P
	Application No.	Applicant(s)
Notice of Allowability	10/784,037	OZAWA ET AL.
Nouce of Allowability	Examiner	Art Unit
	Timothy L. Rude	2871
The MAILING DATE of this communication appears on the cover sheet with the correspondence address All claims being allowable, PROSECUTION ON THE MERITS IS (OR REMAINS) CLOSED in this application. If not included herewith (or previously mailed), a Notice of Allowance (PTOL-85) or other appropriate communication will be mailed in due course. THIS NOTICE OF ALLOWABILITY IS NOT A GRANT OF PATENT RIGHTS. This application is subject to withdrawal from issue at the initiative of the Office or upon petition by the applicant. See 37 CFR 1.313 and MPEP 1308.

DETAILED ACTION

Figure 6(B):

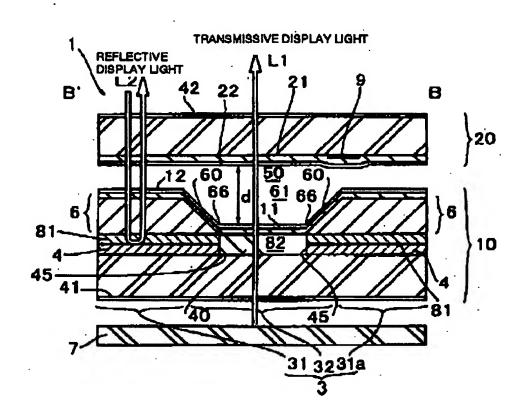
As to independent claims 1, 9, 19, and 20, relevant prior art did not teach, alone or in combination, the transflective liquid crystal display device as claimed comprising a thickness adjusting layer, 6, having an edge substantially proximate to the transmissive display region and a sloping section, 60, that extends from the edge in a direction away

from the corresponding substrate, the edge of the thickness adjusting layer and the slope at least adjacent to the edge being overlapped by a portion of the light-reflecting layer, 4. This structure prevents unwanted transmitted light leakage through the sloped region.

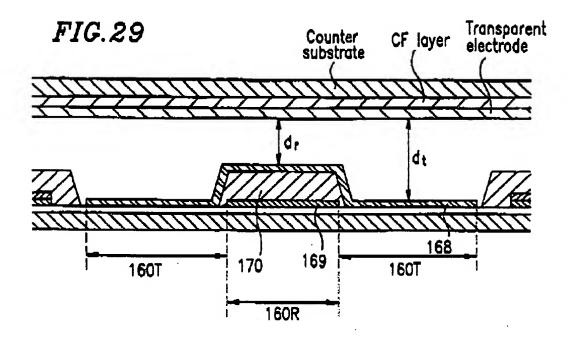
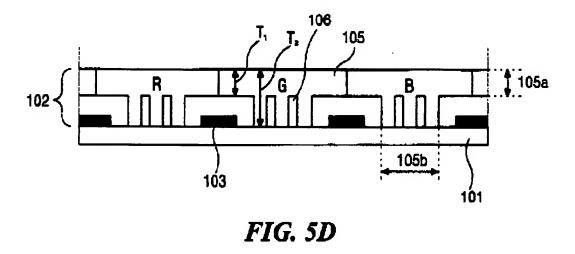
Kubo discloses a transflective liquid crystal device [electronic apparatus, TFTs] comprising:

a first substrate [bottom];

a second substrate [top]; and a liquid crystal layer held between the first substrate and the second substrate, wherein the first substrate includes:

a light-reflecting layer, 169, overlapping reflective display regions in plan view in pixel regions and in a non-overlapping condition with transmissive display regions in the regions of the pixel regions other than the reflective display regions; and

a thickness-adjusting layer, 170, setting the thickness of the liquid crystal layer in the reflective display regions to be smaller than the thickness of the liquid crystal layer in the transmissive display regions; and Art Unit: 2871

slopes are formed in the thickness-adjusting layer at a transition between each reflective display region and transmissive display region; and

edges of the light-reflecting layer adjacent the transmissive display regions are substantially aligned with bottom edges of the slopes of the thickness-adjusting layer [steep slope so reads on substantially aligned per Figure 29].
